Project: New Construction; One Family Residence

Property Location: 1050 Route 9W Upper Nyack NY, 10960

**PB #19-20: 1050 Route 9W Site Plan  
Critical Environmental Area  
Final Site Plan Approval Subject to Conditions  
Neg. Dec.**

**Town of Orangetown Planning Board Decision  
February 26, 2020  
Page 1 of 12**

PROPOSED EROSION CONTROL PLAN FOR 1050 ROUTE 9W

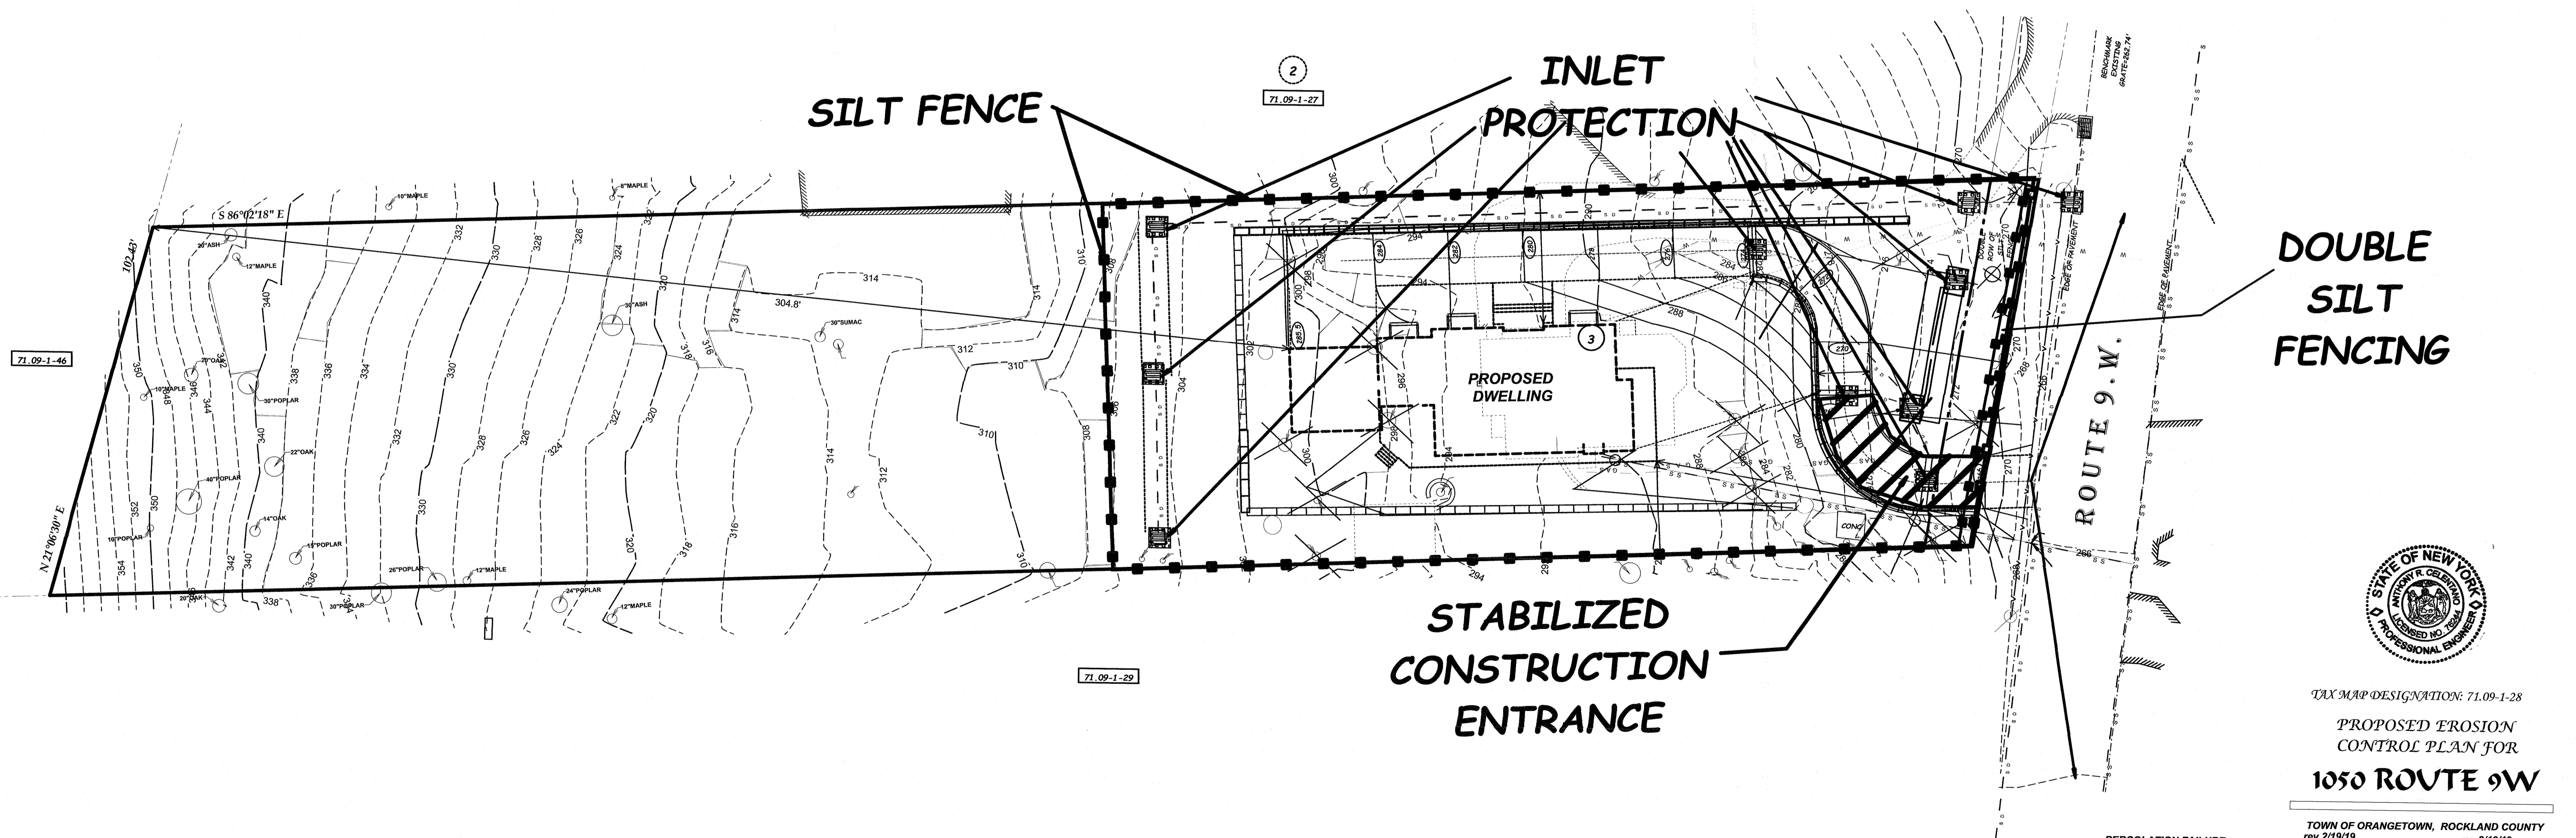
9. The Soil erosion and sediment control symbols shall be added to the required legend. Also, the proposed stabilized construction entrance shall conform to NYSDEC standards symbols.

**OUTLET STRUCTURE**  
NOT TO SCALE

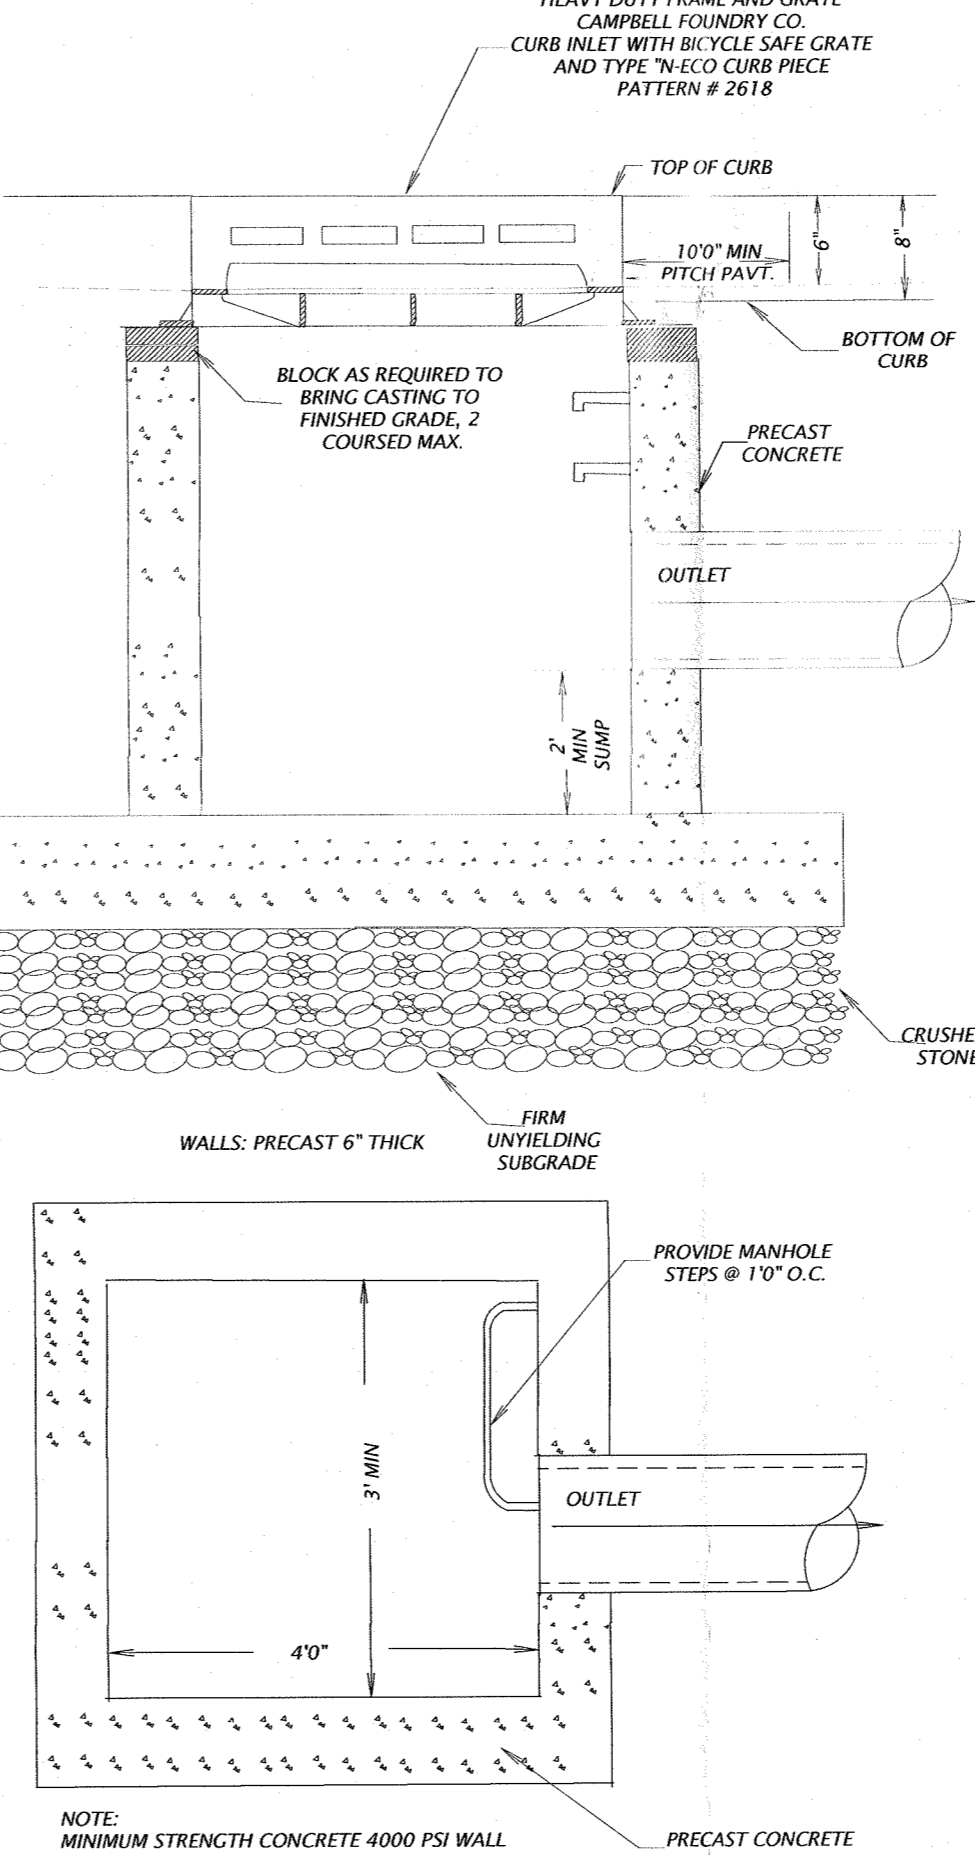
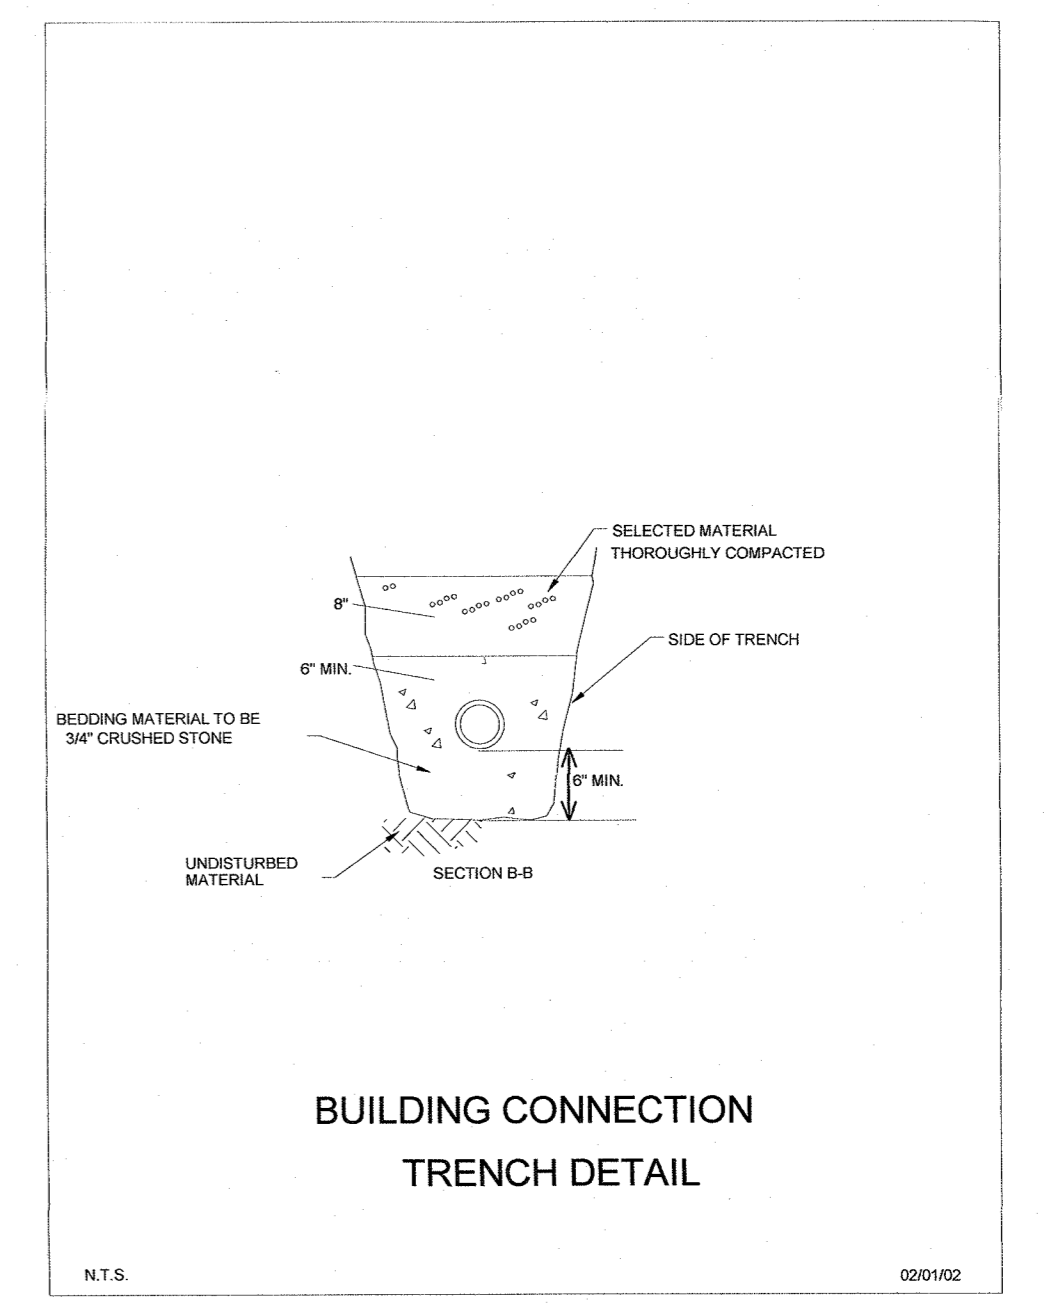
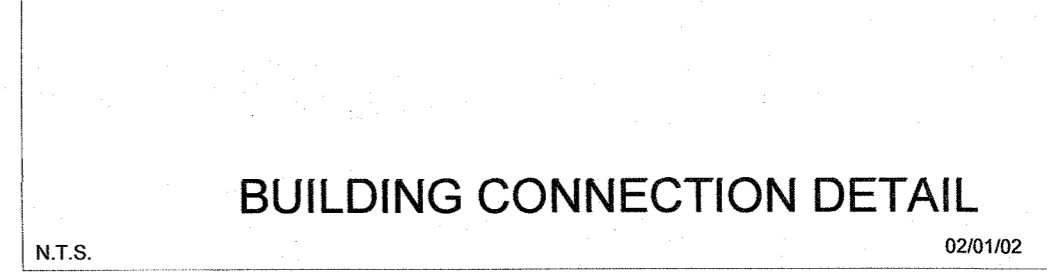
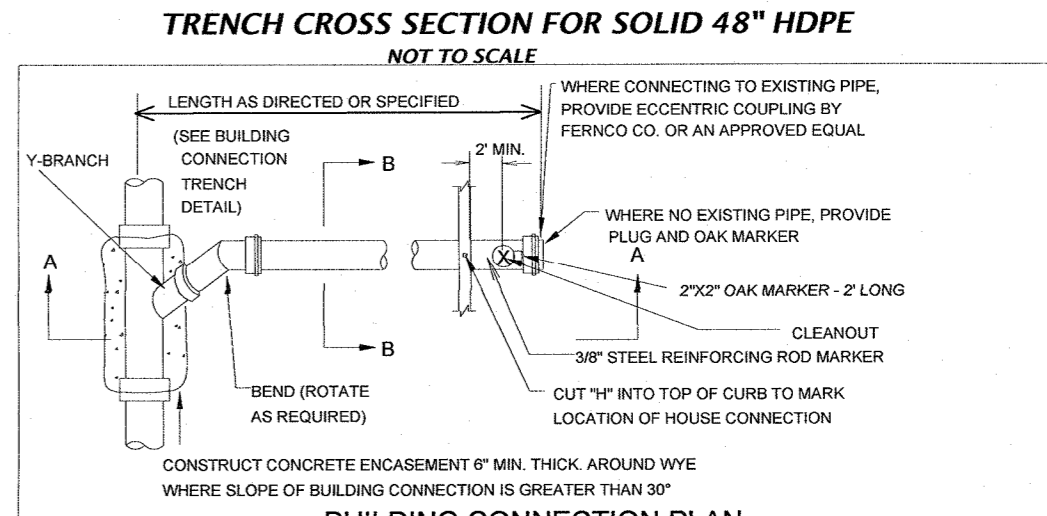
7. As per the November 13, 2019 report, the outlet structure detail shows a 6-inch low flow opening but does not show the additional openings included in the routing calculations. Manual access to the one foot wide section on the outlet structure shall be demonstrated. The rim elevation shall be added to the outlet structure detail.
